Fresno - Bakersfield (July 2012+) - RECORD #375 DETAIL

Response to Submission I001 (Claire Davenport, October 19, 2012)

Fresno to Bakersfield High-Speed Train Section
Revised Draft Environmental Impact Report/
Supplemental Draft Environmental Impact Statement
(Revised Draft EIR/Supplemental Draft EIS)

32. Page 2.0-109 Table 2-17 Missing Design Phases

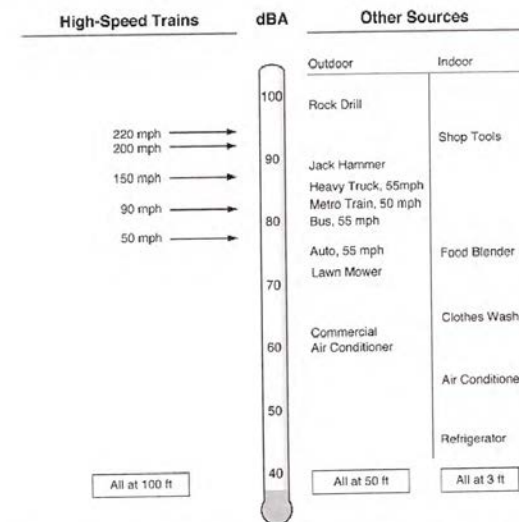
Presented in Table 2-17 is a schedule for the project, however what is missing is the design phases of this project. The DEIR/EIS explains that this project will be constructed under the Design/Build concepts, which will allow the contractor who builds the system to also design it. This process however does not eliminate the need for design. The current status of the plans are at 15%, which is significantly under designed for a DEIR/EIS analysis, and requires the contractor to carry the design out to 100%. There is not time allocated in this unrealistic time schedule to allow for design.
